INSPECTION REPORT
Sedimentation Structure
J7-M
Black Mesa Mine
Navajo County, Arizona
for
PEABODY COAL COMPANY

Dames & Moore
10139-011-22

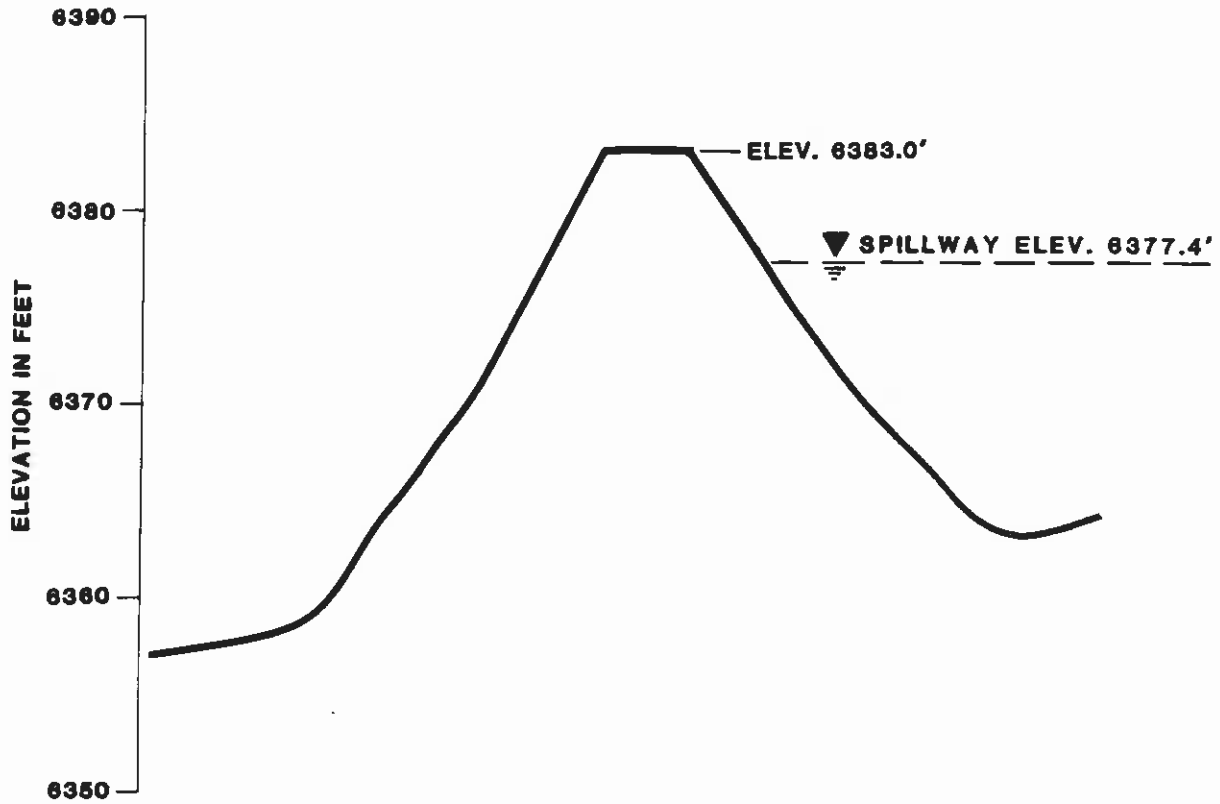
The storage capacity and spillway capacity of Structure J7-M are adequate; however, the spillway does not have an adequate outflow channel. A trapezoidal outflow channel should be constructed along the alignment B-B' shown in Plate 1. The channel profile is shown in Plate 4 and the required dimensions are shown in Plate 5. The outflow channel should be protected against erosion using geotextile and riprap as shown in Plate 5. A trash-rack should be installed on the inlet of the CMP to prevent clogging of the spillway.

EXISTING
MAXIMUM CROSS-SECTION
A-A'
J7-M

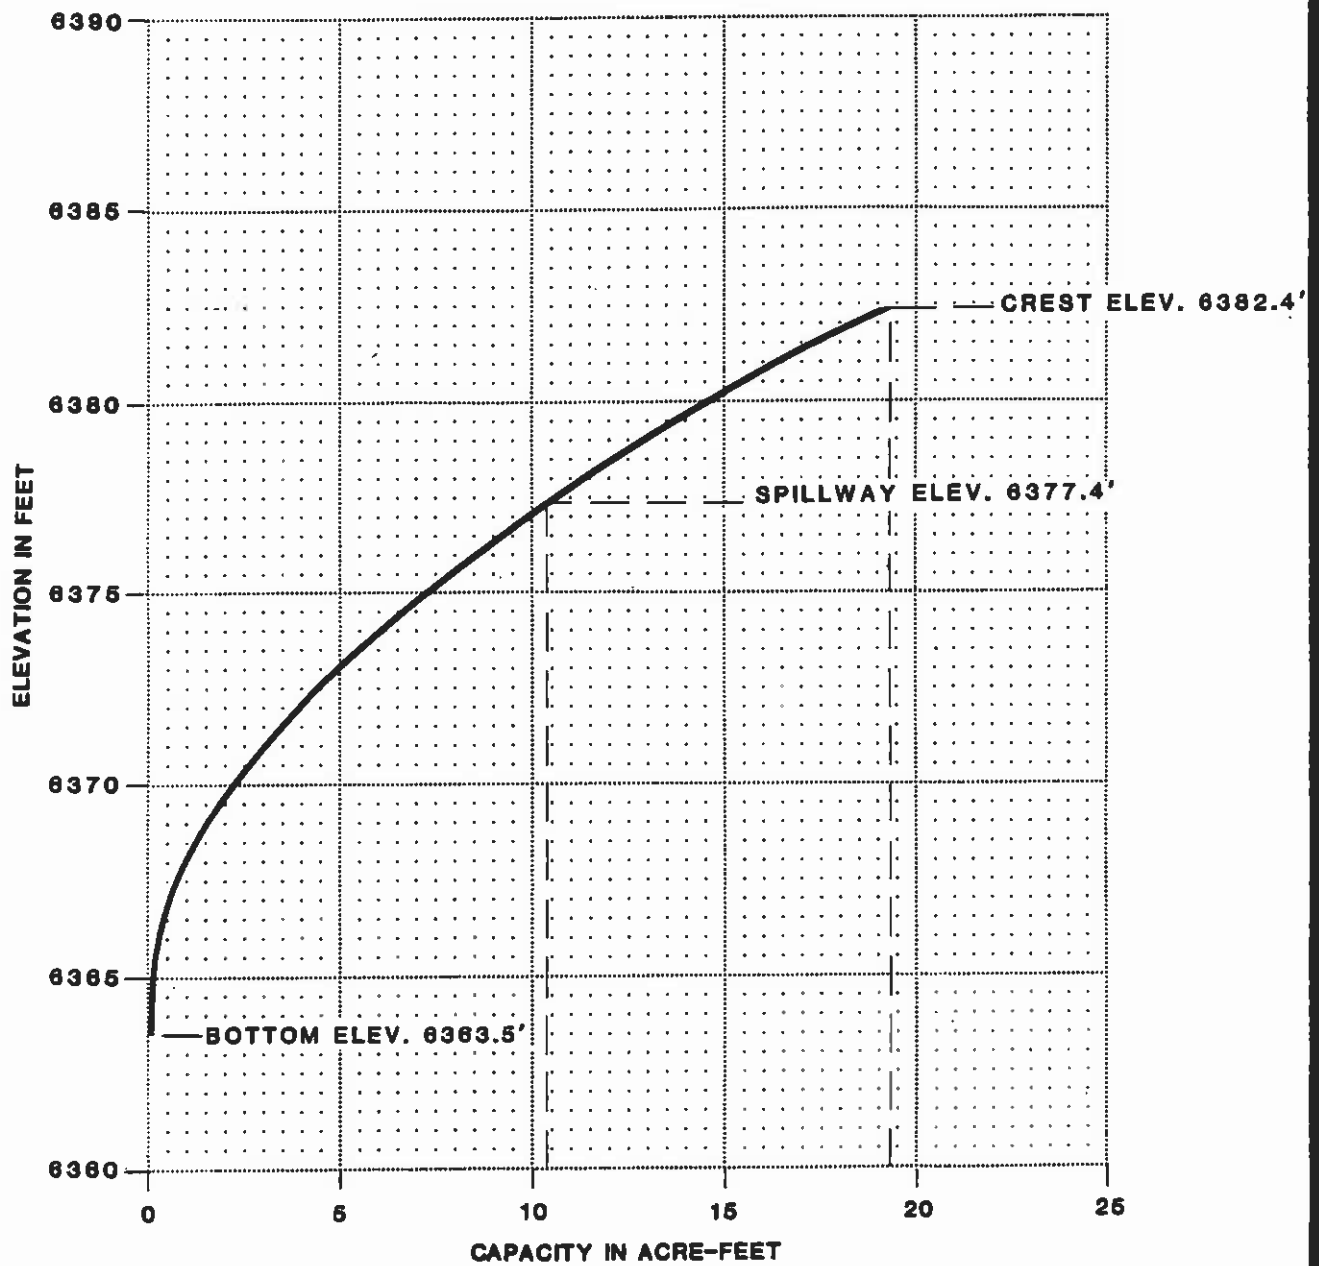
The J7-M embankment is lower in height; however, the downstream slope is steeper than the category standard; therefore, the embankment has factors of safety less than the design minimum.

The inspection of Structure J7-M indicated that the geotechnical problems consist of rills on the upstream and downstream slopes and gullies in the right and left abutments; and a steep downstream slope. Correction of erosion is considered a periodic maintenance task and does not require

remedial action. The downstream slope should be flattened to 4.0 horizontal to 1 vertical to meet stability requirements.
